FREQUENTLY ASKED QUESTIONS

July 2026

State/Federal Project No. CFHWY00604/0001659

AMATS: Spenard Road Rehabilitation
Minnesota Drive to Benson Boulevard Project

Typical Section

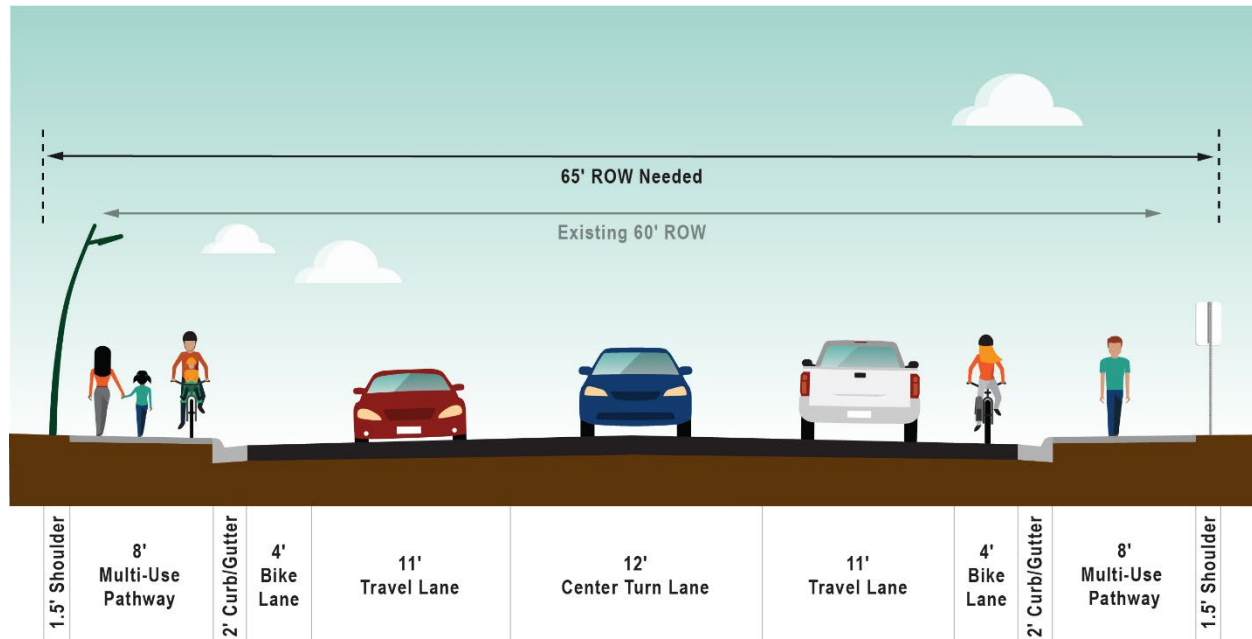
What will the road look like compared to the existing road?

Can the motorized travel lanes be narrowed to provide 6" more to the bike lanes?

The previous section of Spenard Road rehabilitation had limited width for bicycle lanes (5 feet including the gutter pan). What kind of feedback has there been from bicyclists on the safety of these slightly narrower bicycle lanes, and could this be a solution in the current project as well?

This section of Spenard Road is currently a 4-lane roadway with sidewalks on both sides. The proposed typical section (shown above) is a 3-lane roadway with on-street bike lanes and multi-use pathways on both sides.

As a federally funded project, all ROW acquisitions must comply with the Uniform Relocation Assistance and Real Property Acquisition Act. Acquisitions for the travel lanes and the center turn lane are justified by the project's adopted design standards. The widths of the non-motorized facilities in the current typical section also meet those standards, widening them would exceed them.

The project's authority to acquire ROW is limited to what is necessary and should generally be supported by the project's adopted standards. In other words, the vehicle travel lane widths can be justified for acquisition, but a bike lane exceeding adopted design standards cannot. For this reason, the project team cannot reduce the width of other roadway elements and reallocate that space to widen the bike lanes.

The current design incorporates wider on-street bicycle lanes on this segment (5.5 foot including the gutter pan). Feedback has included requests for an even wider bike lanes, exceeding the project standards. Widening the lane further would require additional ROW acquisitions not supported by project standards.
